GEORGIA POWER COMPANY
OGLETHORPE POWER CORPORATION
MUNICIPAL ELECTRIC AUTHORITY OF GEORGIA
CITY OF DALTON, GEORGIA
DOCKET NO. 50-321
EDWIN I. HATCH NUCLEAR PLANT, UNIT NO. 1
AMENDMENT TO FACILITY OPERATING LICENSE

Amendment No. 157
License No. DPR-57

ATTACHMENT TO LICENSE AMENDMENT NO. 157

Replace the following pages of the Appendix A Technical Specifications with the enclosed pages. The revised page is identified by amendment number and contains a vertical line indicating the area of change.

FIGURE 3.11-1 (SHEET 5)

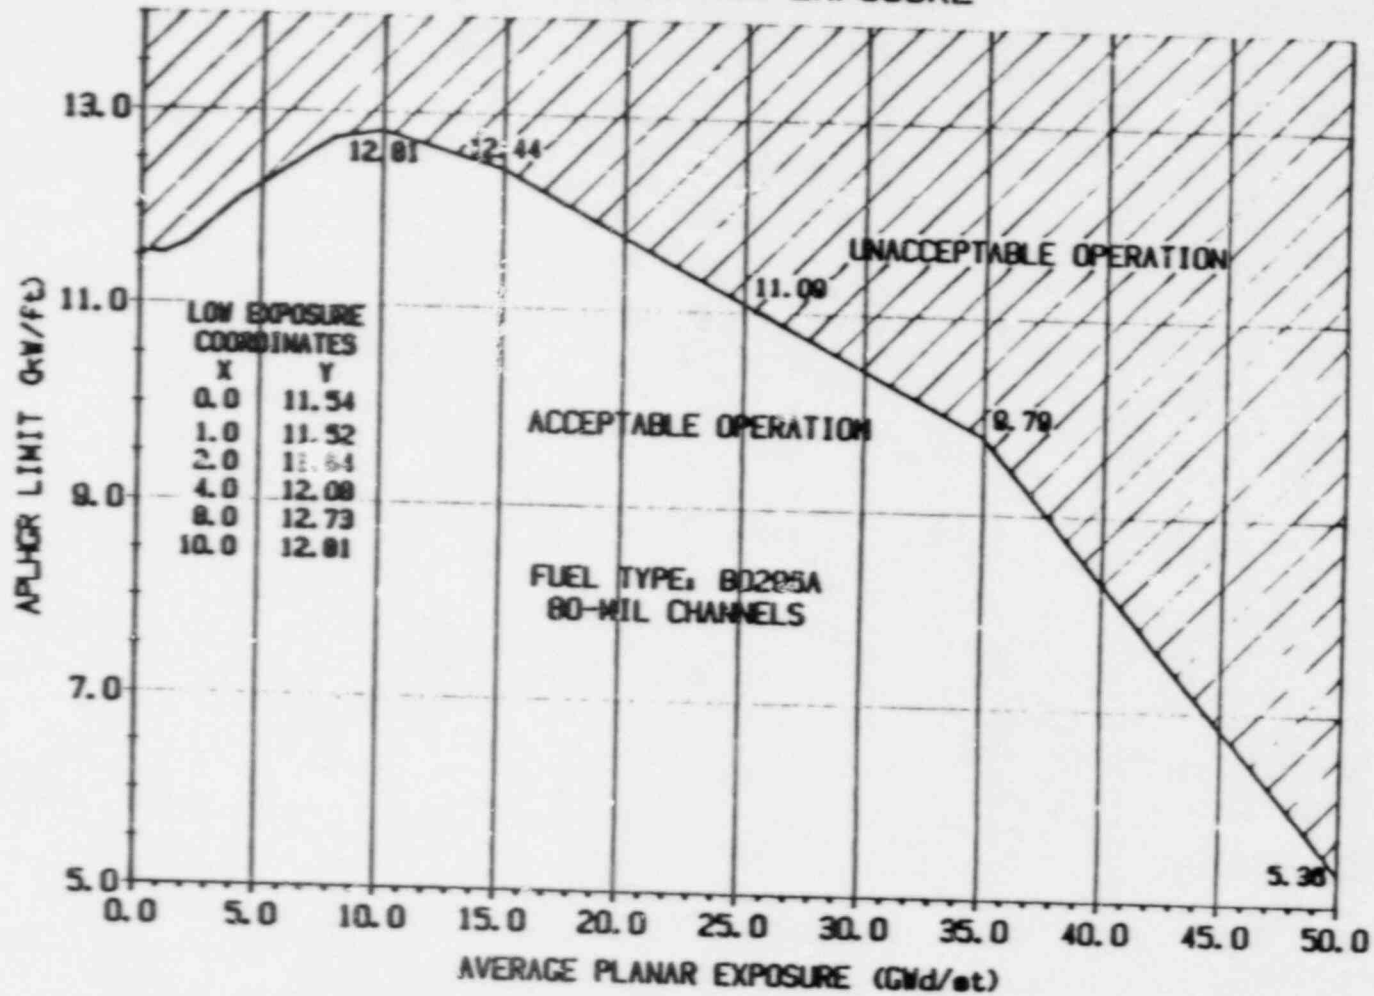
<u>Remove Page</u>	<u>Insert Page</u>
X	X
Xi	Xi
3.11-1a	3.11-1a
3.11-2	3.11-2
3.11-3	3.11-3
3.11-4	3.11-4
3.11-4a	3.11-4a
Figure 3.11-1 (Sheet 4)	Figure 3.11-1 (Sheet 4)
Figure 3.11-1 (Sheet 5)	Figure 3.11-1 (Sheet 5)
Figure 3.11-1 (Sheet 6)	Figure 3.11-1 (Sheet 6)
Figure 3.11-1 (Sheet 8)	Figure 3.11-1 (Sheet 8)
Figure 3.11-2	Figure 3.11-2
Figure 3.11-4	Figure 3.11-4
Figure 3.11-5	Figure 3.11-5

NOTE: THIS IS THE ALPHA-R LIMIT FOR THE MOST LIMITING LATTICE AS A FUNCTION OF AVERAGE PLANAR EXPOSURE.
